**RE: Preliminary Large Well Siting/Large Groundwater Withdrawal Permit Application  
 Aquarion Water Company, PWS ID 1051010  
 Well 22  
 Hampton, New Hampshire**

RE: Large Groundwater Withdrawal Application by Aquarion Water Company of New Hampshire, Well 22, Hampton, NH

**Review and Comments on Large Groundwater Withdrawal Application and Preliminary Report and Large Groundwater Withdrawal Permit Application (Env-Wq 403, Env-Ws 302) Aquarion Water Company of New Hampshire Well 22, Little River Road Hampton, NH (24 Mar 2017)**

Figure 2. Mapped stratified drift deposits (USGS/NH GRANIT)

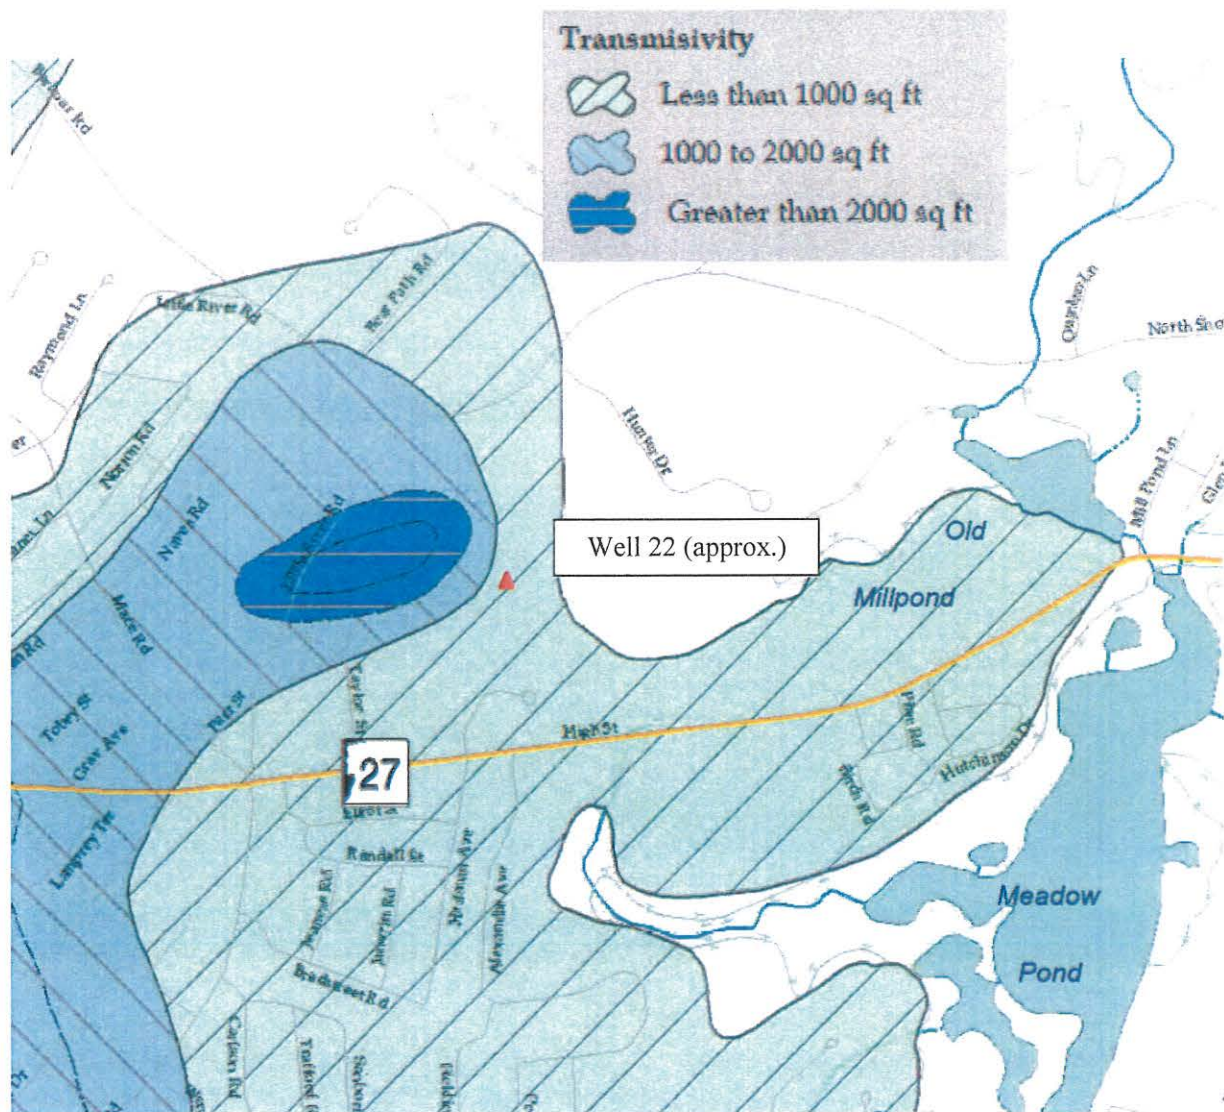
Wetlands were given little discussion in the report. Many towns have gone to great lengths to protect and preserve their wetlands, including Hampton and North Hampton. The mapped wetlands from NH Coastal Viewer may be found in Figure 1 below, depicting large fresh and salt water marsh complexes all within the expected wellhead area. Figure 2 below displays the mapped stratified drift deposits near to Well 22. There is overlap between the stratified drift and nearby wetlands; therefore wetlands may already be stressed by groundwater pumping. Care should be taken to clearly distinguish bedrock pumping stress from overburden stress. Additional piezometers located in appropriate wetland areas should be required as part of the pumping test monitoring regime as well as for longer term monitoring.

Figure 3. Projected system drawdowns during the pumping test.

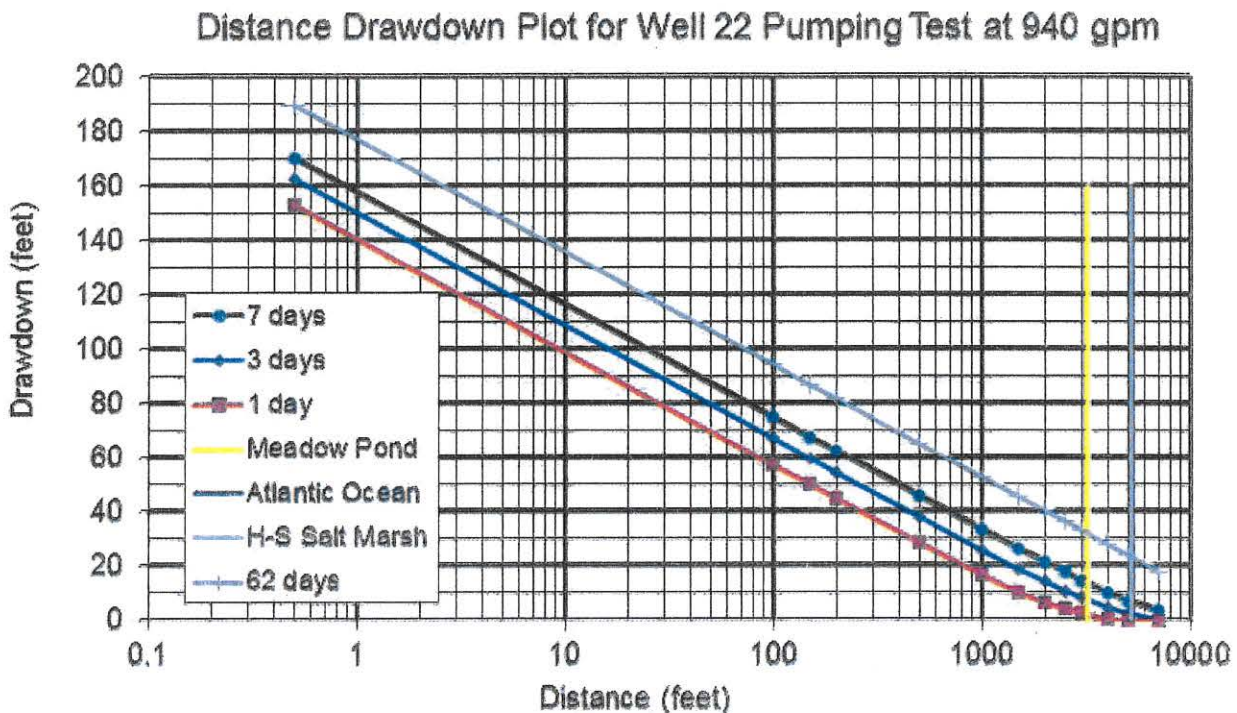
Using these bedrock parameters at the Well 22 site (T = 1,600 ft<sup>2</sup>/day, S = 0.0006), distance drawdown plots for the proposed pumping test have been developed and are displayed in Figure 3 below. It is estimated that during this pumping test, the water level of Well 22 should remain above the maximum allowable drawdown of 209 feet (highest fracture at 219 ft bgs and depth to water of 10 feet). As is evident, though, there are dramatic drawdowns (over 30 feet) 1,000 feet away from the pumping well. By the end of the pumping test at 3,000 feet away from the pumping well there could be 15 feet of drawdown, certainly measurable and distinguishable from natural water level changes. Below wetlands at 1,000 feet, there could be over 30 feet of drawdown, also easily distinguishable in wetland/streambed piezometers. The nearest homeowner wells could see more than 40 feet of drawdown.

Section	Page	Text/concept from application	Comment
6.0	18	Water level monitoring in bedrock wells beyond the well site during pumping of Well 22 has yet to be conducted. The potential for impacts to private wells and/or other water users within the Preliminary WHPA exists. The proposed withdrawal testing program will address and evaluate potential impacts to these users, by monitoring those within 1,000 ft. of Well 22, and a representative selection of those within the Preliminary WHPA.	For a confined formation, monitoring within 1,000 feet is not far enough to demonstrate the consequences of long term pumping, including: salt water intrusion, drawdown in homeowner wells, reduction in stream low flows, and wetlands dewatering. Refer to Figure 3 above to understand the magnitude of potential consequences.

Figure 4. Distance-drawdown plot for long term pumping of Well 22 at the lowest desired withdrawal rate.

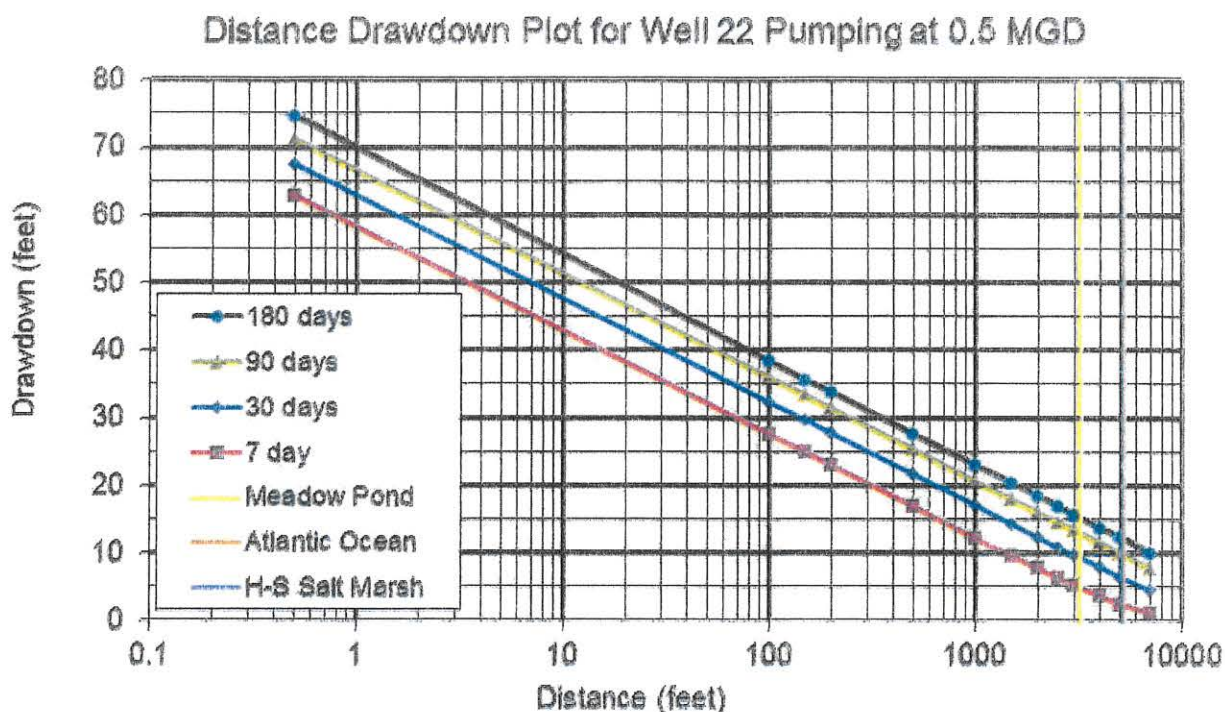
Using these same formation parameters, the long term consequences of pumping Well 22 may be estimated. While the pumping test is planned at 940 gpm, the long term sustainable yield may be much less. For the purposes of illustration, a rate of 347 gpm (0.5 MGD) was used as the long term pumping rate. Figure 4 below depicts system drawdowns under a sustained withdrawal of 0.5 MGD. Long term pumping at this rate results in the Well 22 dynamic water level maintained above the 209 feet maximum allowable drawdown. However, thousands of feet away, there are projected to be large drawdowns at Meadow Pond, the Atlantic Ocean, the closed Hampton landfill, and the Hampton-Seabrook salt marshes. There are potentially three former unlined landfills in the projected drawdown area. The first is located by the Hampton DPW, bounded by Hardardt's Way on the east and north. This site is identified in OneStop and in the Application's Appendix E. The second is located on Island Path in a marsh area. Local knowledge identifies it was probably a burn dump. The third is in the area of the bridge on Rt. 101 going towards the beach. Apparently it was another old burn dump that was used as fill under Rt. 101. These and other known or potential hazards should be considered in the development of the monitoring program, as well as integrating existing monitoring networks into same. Drawing contamination into the Aquarion wells is one issue, but another is moving contaminants into other areas of the aquifer as a result of the pumping of the new well, even for the pumping test.

Individual homeowner wells near to Well 22 could see long term well water levels reduce by 20 feet or more. This has the potential to render these wells unable to meet demands during critical dry periods. In addition, this permanently increases the pumping burden and costs to individual homeowners. One well owner has an open well geothermal system which could also be compromised by long term Well 22 pumping. This topic should be addressed by the Applicant.
